# Technical Service Information

## **THM 4T60-E COMPLETE HYDRAULICS CHANGE FOR 93-94**

**Figure 1**

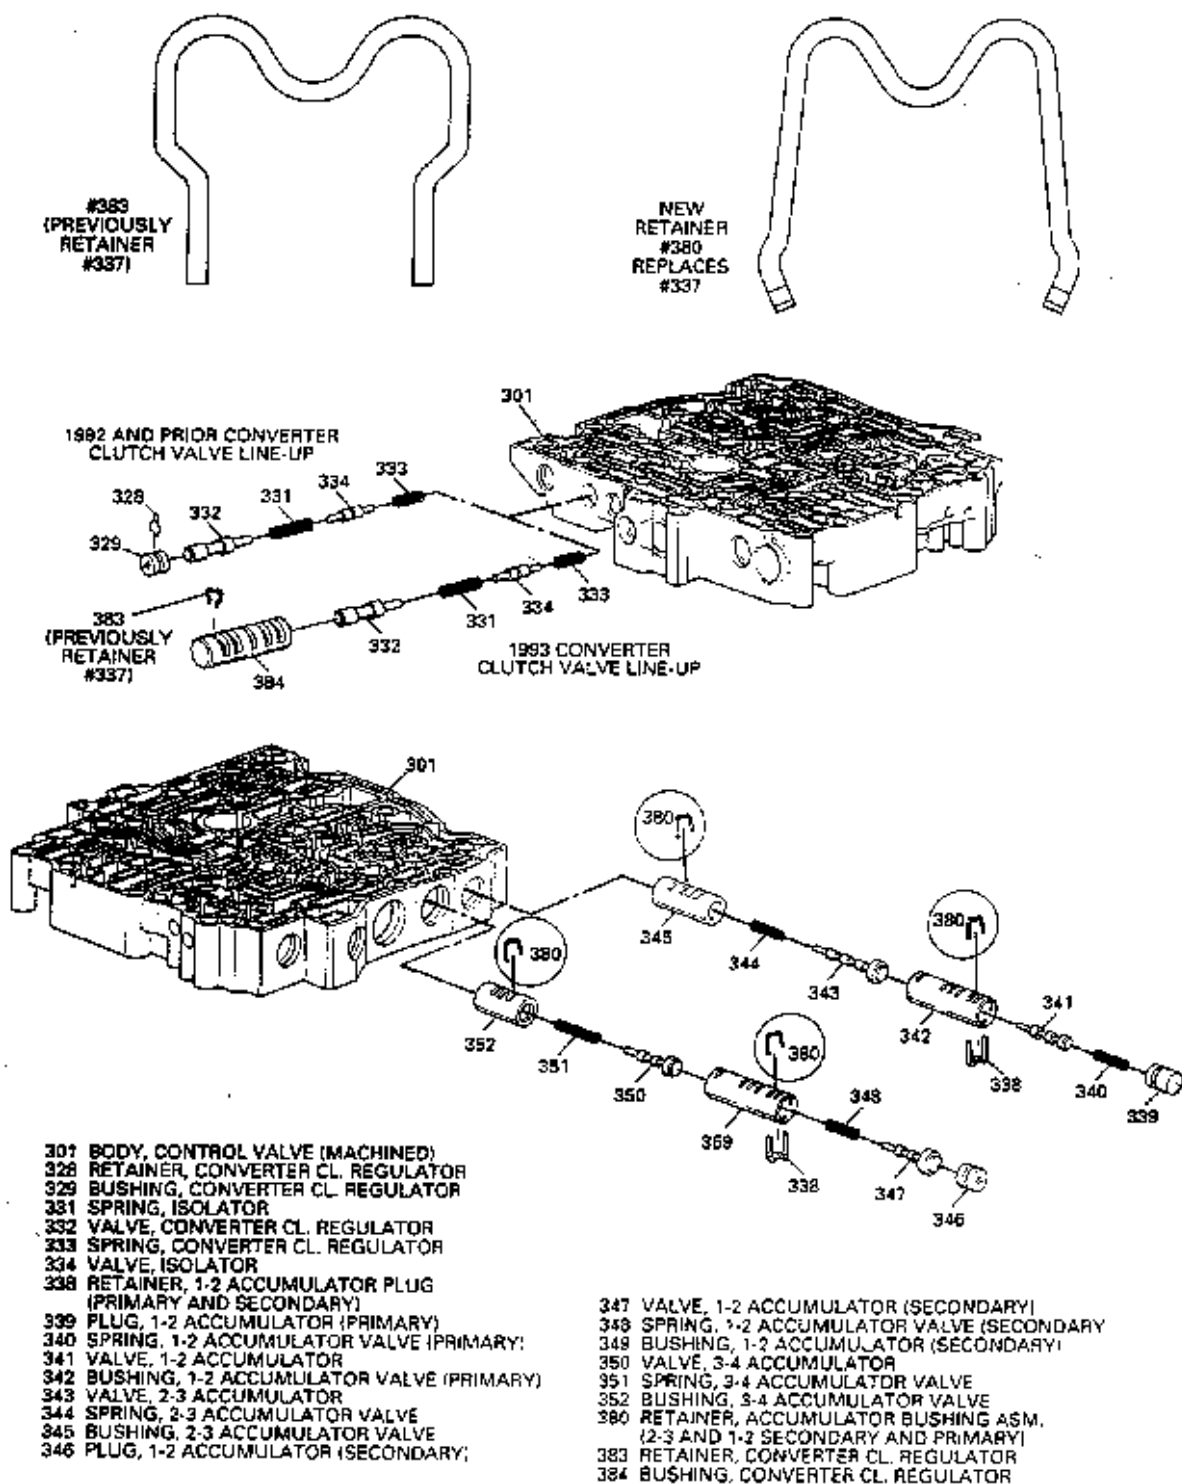
(1) **VALVE BODY CASTING** - The aluminum plug and retainer clip for converter clutch regulator valve were eliminated, and replaced with a new bushing and new style retainer, as shown in Figure 1. The 1-2 accumulator valve bushings (Both Primary and Secondary), the 2-3 accumulator valve bushing, and the 3-4 accumulator valve bushing were revised to accommodate new design retainers with more holding capacity, as shown in Figure 1.

Figure 2

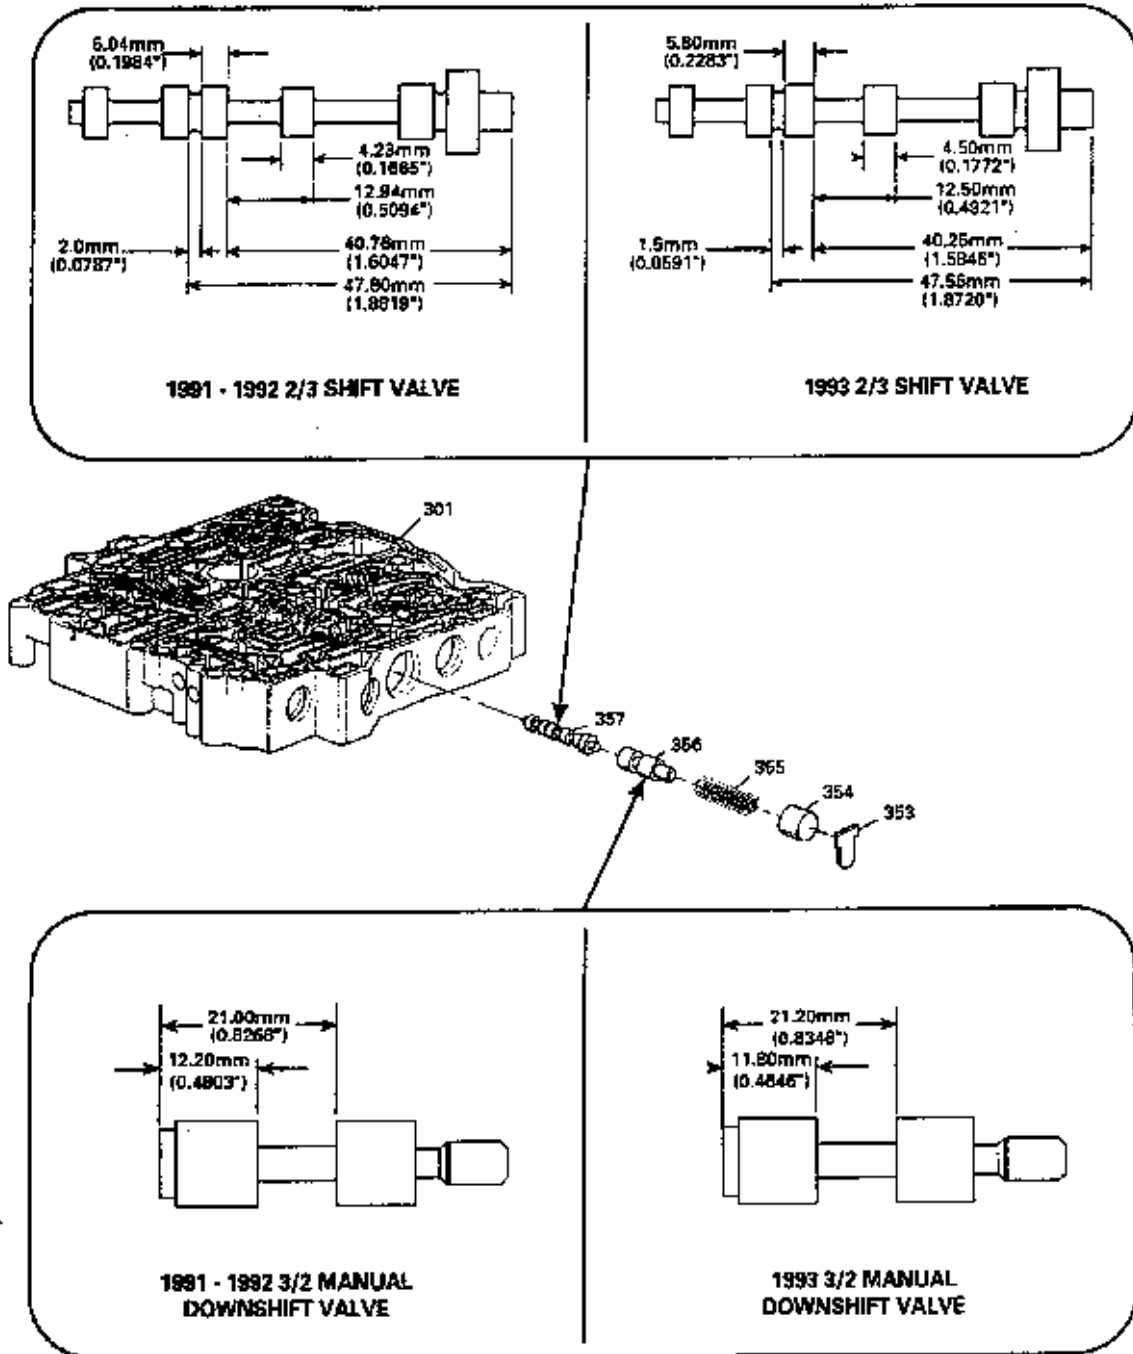
The 2-3 Shift Valve and the 3-2 Manual Downshift Valve received some dimensional changes, as shown in Figure 2. These changes required changes in the Valve Body Casting, in the worm track areas of both sides, and the differences are shown in Figure 3. Note that there are not any check ball location changes.

**Figure 4**

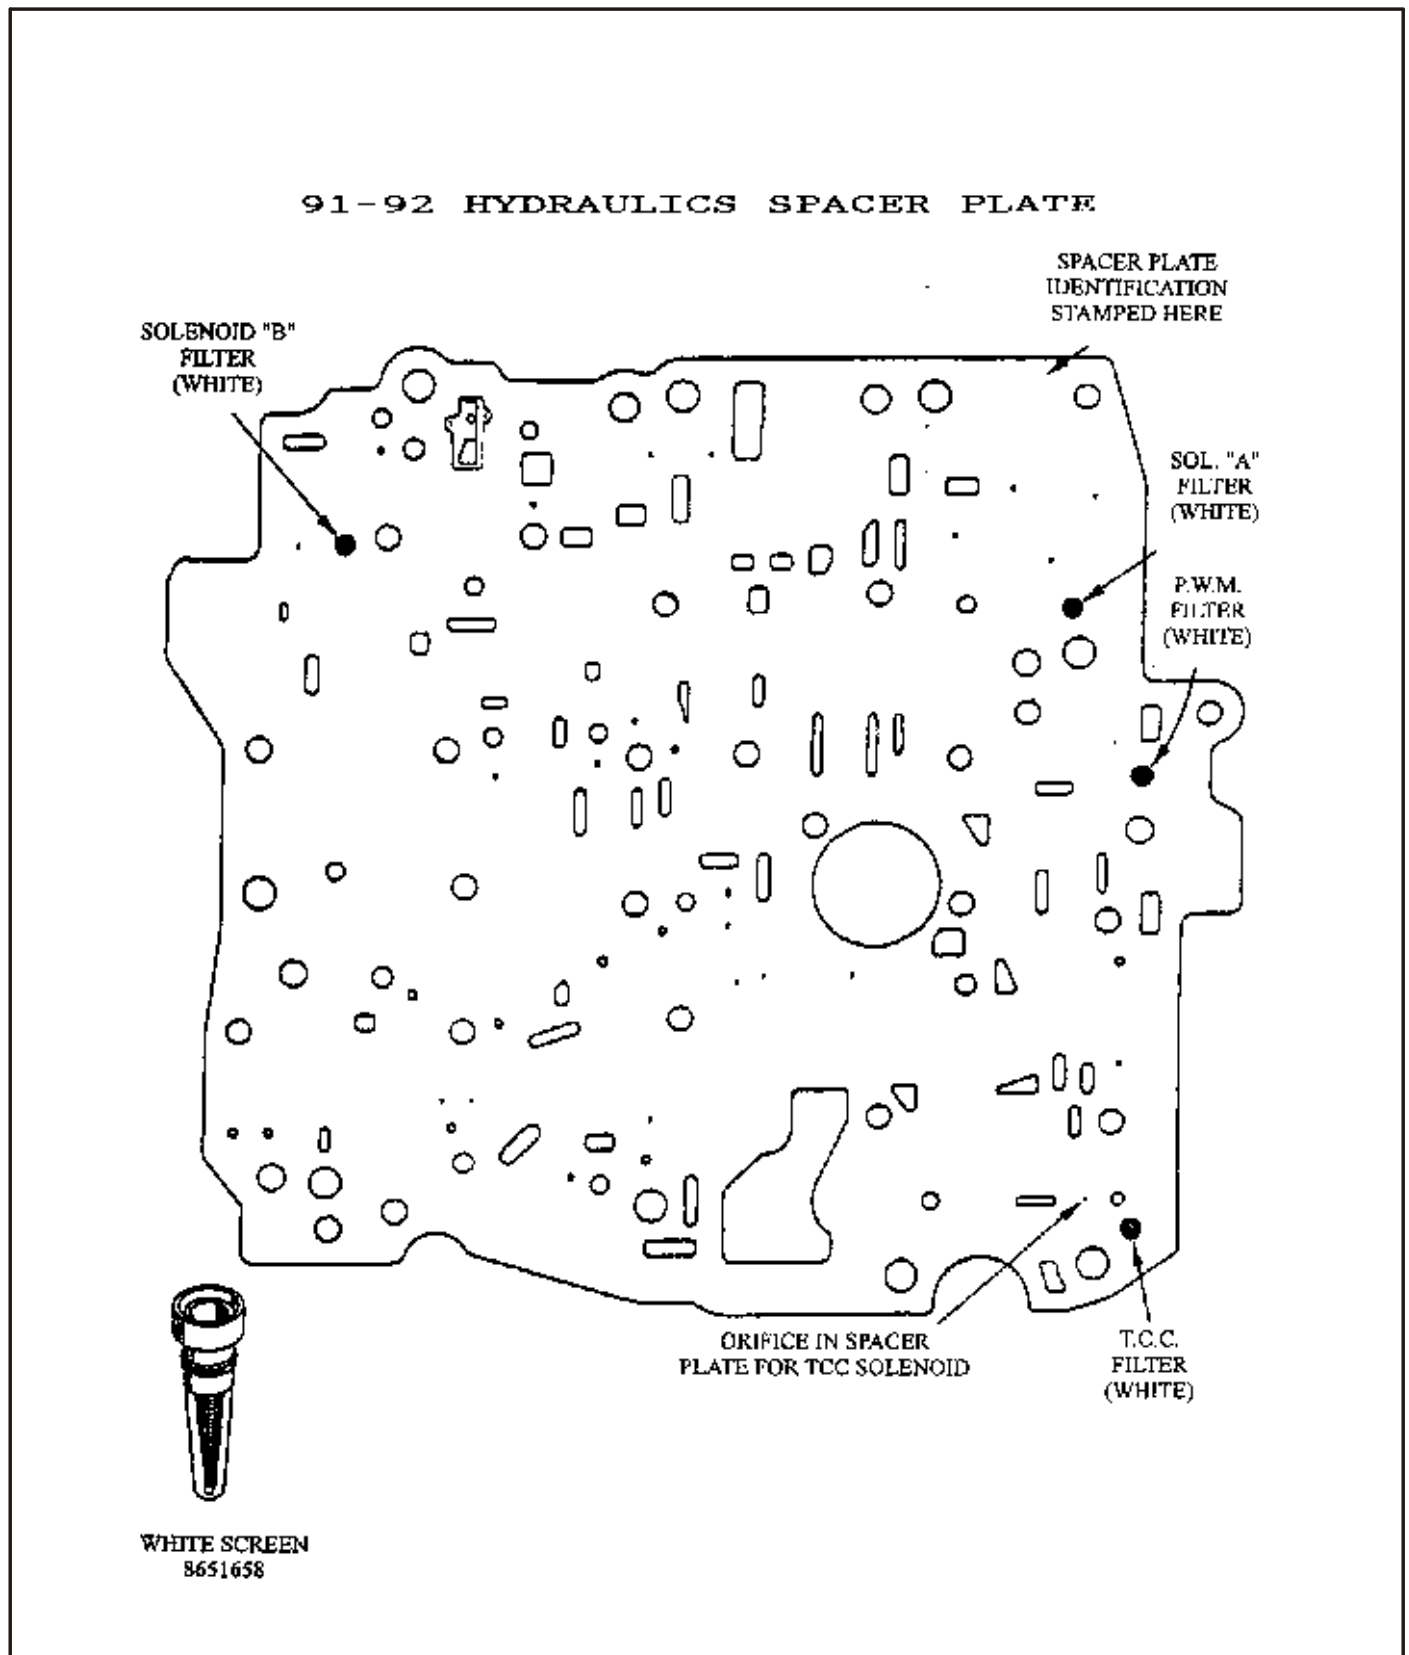
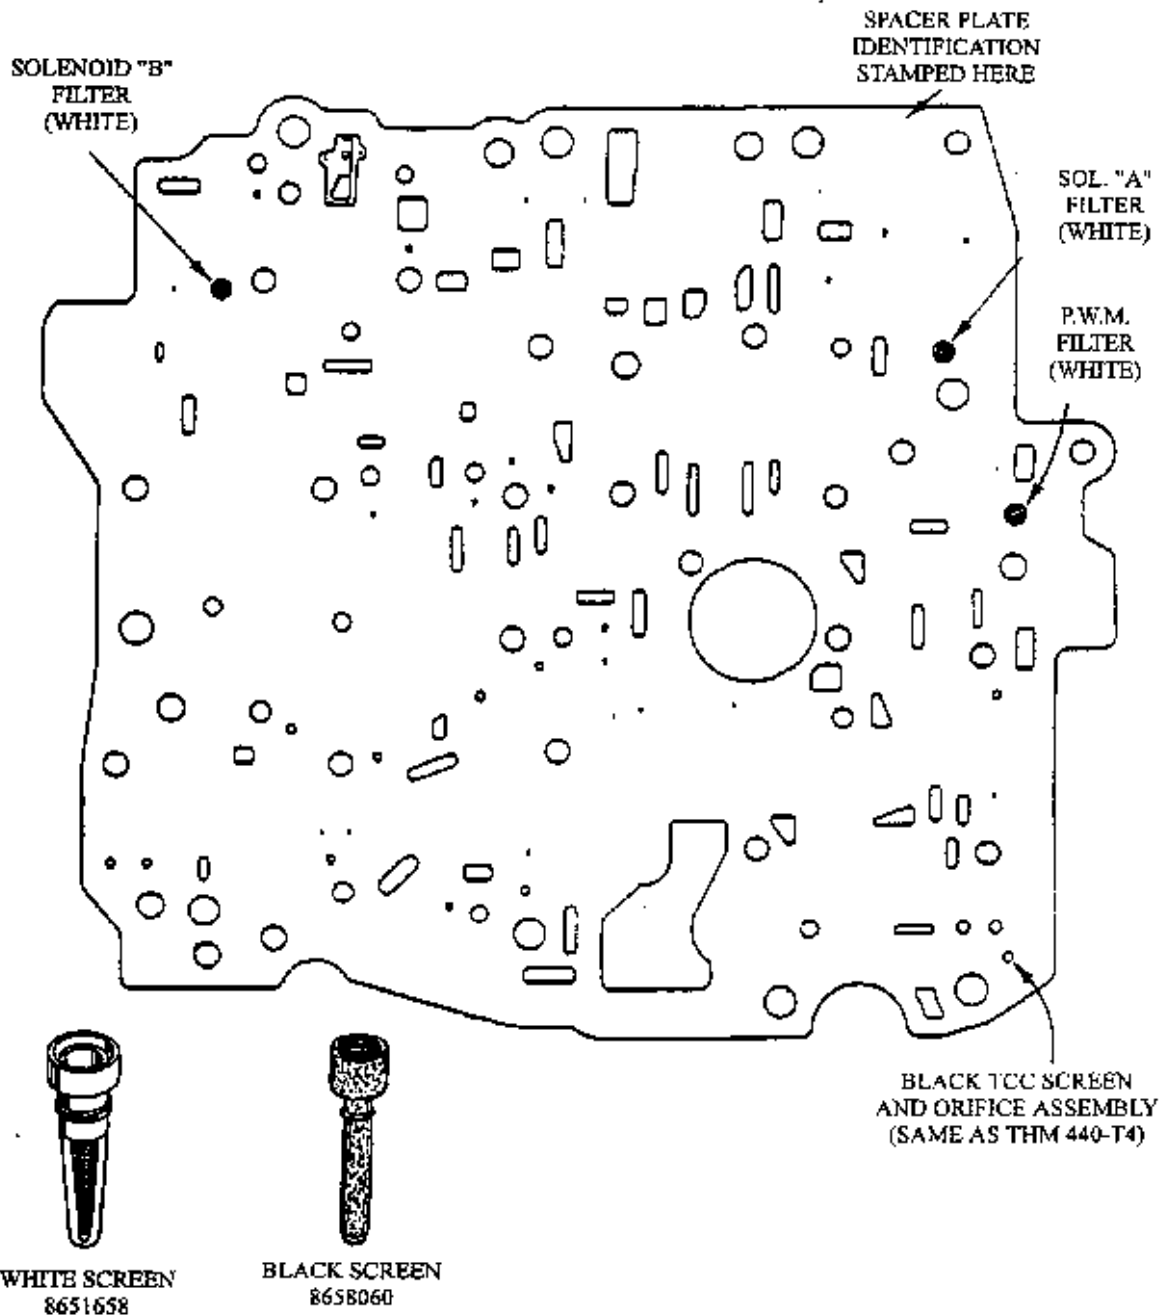
(2) **VALVE BODY SPACER PLATE** - Different hole spacing-to accommodate the valvebody and channel plate casting changes. Also the 91-92 hydraulics spacer plate has the TCC solenoid orifice in the spacer plate, and the 93-94 hydraulics requires the same screen and orifice assembly, with "O" ring, that is currently used in the THM 440-T4 transaxle and is shown Figures 4 and 5.

Figure 6

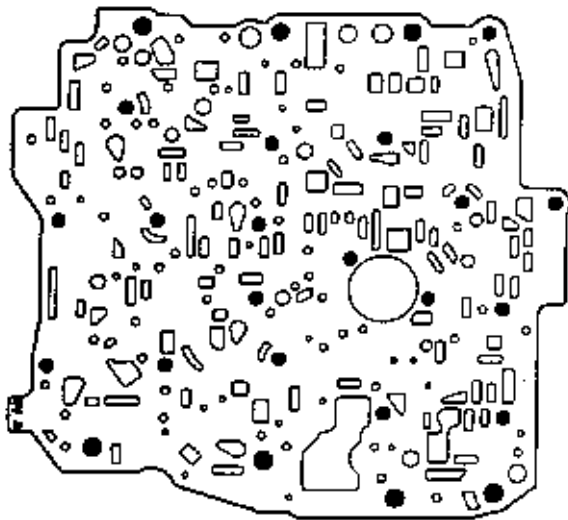
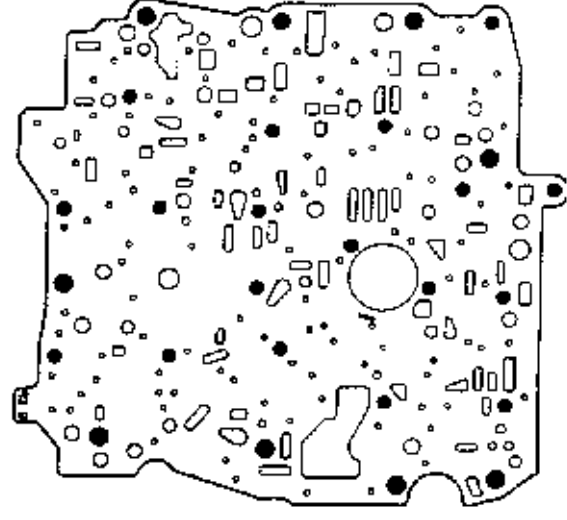
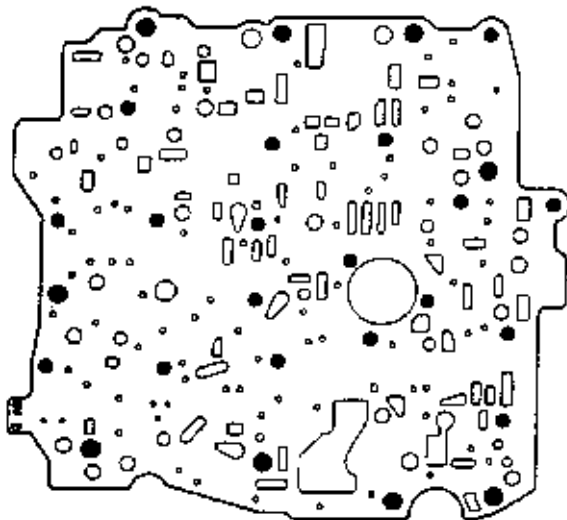
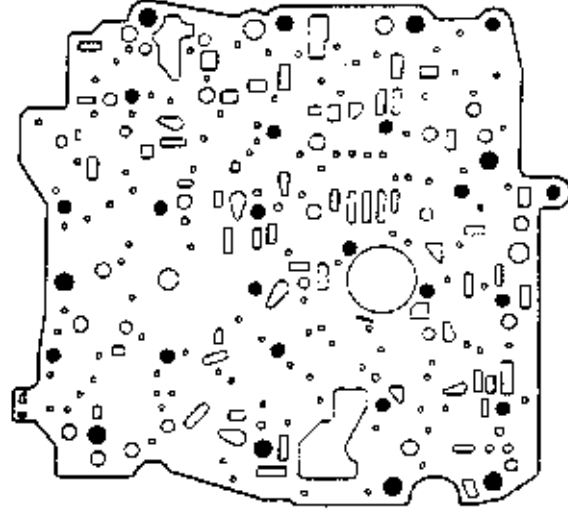
(3) **VALVE BODY GASKETS** - Both the valve body to spacer plate, and spacer plate to channel plate gaskets change to accommodate the revised hydraulics. They are easily identified by the OEM part number ink stamped on each gasket. Refer to Figure 6 for proper identification.

Figure 7

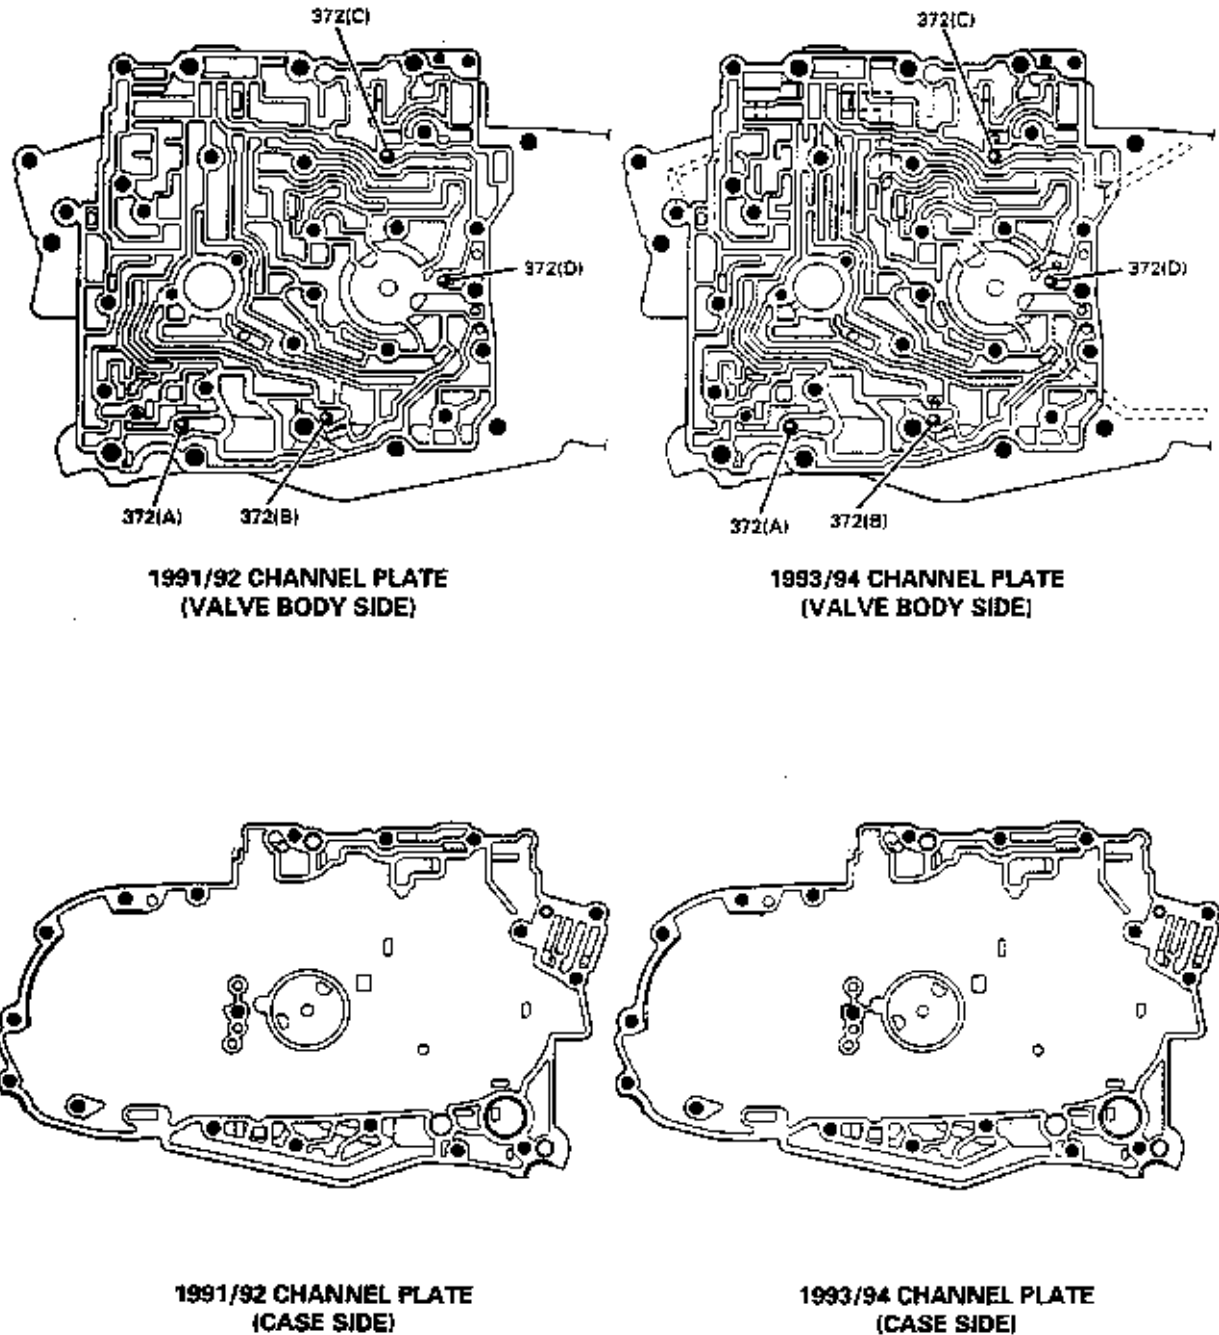
(4) **CHANNEL PLATE ASSEMBLY** - There are casting changes in the worm track area to accommodate the valve body changes, as shown in Figure 7. The Channel Plate can be easily identified by the casting number. Refer to Figure 8 for casting number location. The casting number for the 91-92 hydraulics is 8667284, and casting number for the 93-94 hydraulics is 8682217, and is shown in Figure 8. There was also a change in the Lo Blow Off Valve and Seat, which is also located in the channel plate. These changes are shown in Figure 9.
